# Dual-signature LLDP v120

**Lennart Yseboodt**Philips Lighting – Research
June 21, 2017

## Summary

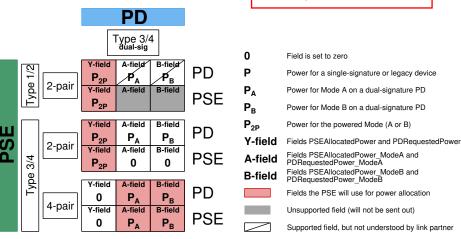
The core change compared to D2.5 is that fields that are not applicable, are set to zero. This prevents duplicate information being sent. Duplicate fields have potential to confuse.

Another change would be to allow dual-signature PDs to request power on a pairset that is unpowered. This is a valid use-case, currently disallowed by a requirement.

#### **Full overview**

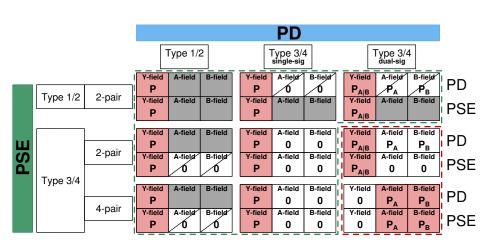
Yair: See corrections to be made in previous slides.

Yair: See corrections to be made in previous slides.
